SERVICE DIRECTIVE BULLETIN NO. 0082

Revision A

1. SUBJECT: Inadvertent Trim Motor Operation on 24 Volt D.C. Systems
2. MODELS: All F-28F, 280F and 280FX models equipped with 24 volt D.C. electrical systems and any F-28C, F-28C-2, or 280C models that have been converted to a 24 volt D.C. system
3. EFFECTIVITY: Prior to the next flight and as noted under compliance.
4. BACKGROUND:

FIG. 1

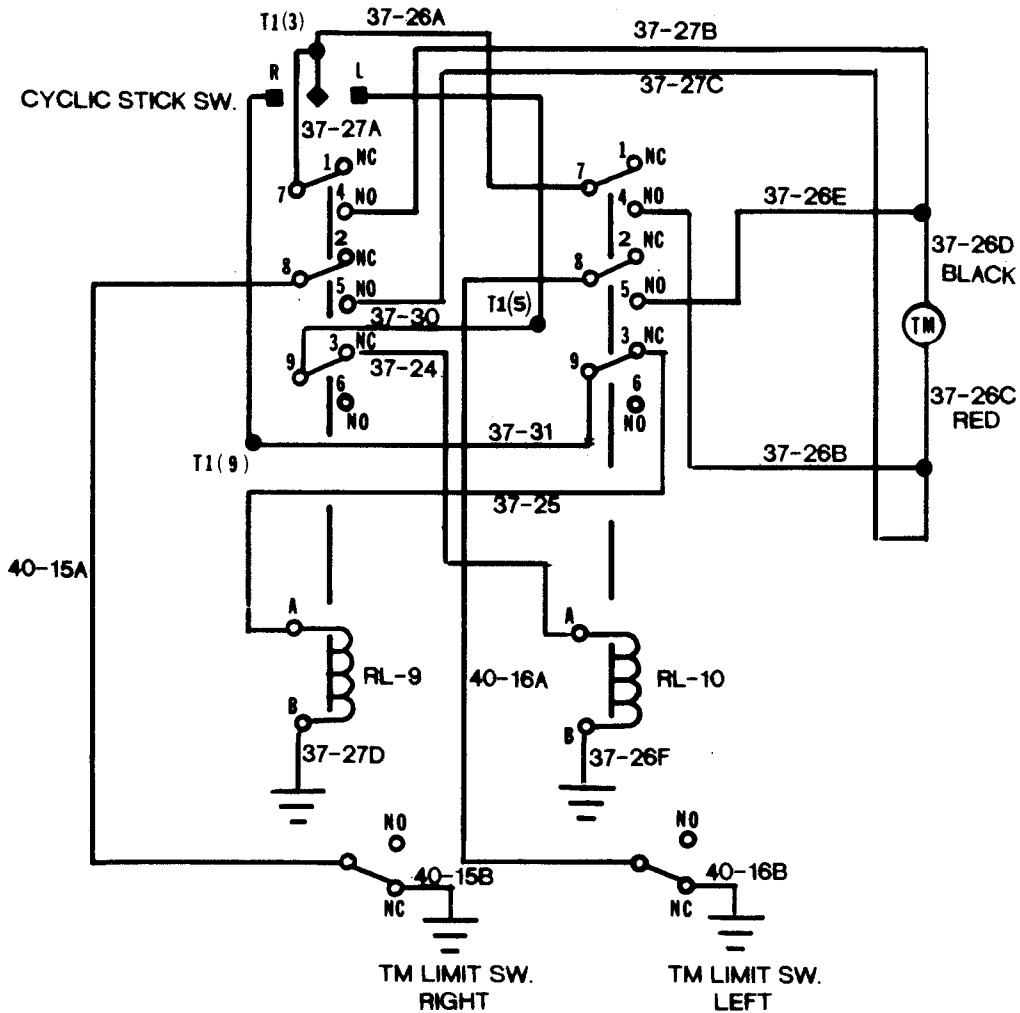
- 5.2 Any trim actuator assemblies found with deformed limit switch brackets must be replaced with an airworthy assembly and control relays.
- 5.3 Within the next 5 hours of time in service and after receipt of this Service Directive Bulletin, the following change to the trim actuator wire harness interconnect to the control relays must be made. See Figures 1 and 2.

- 5.3.2 On the longitudinal trim, relay RL-8, move wire # 40-13A from pin B to pin 8, move wire # 37-23D from pin 8 to pin B. On relay RL-7, move wire # 40-14A from pin B to pin 8, move wire # 37-22F from pin 8 to pin B.
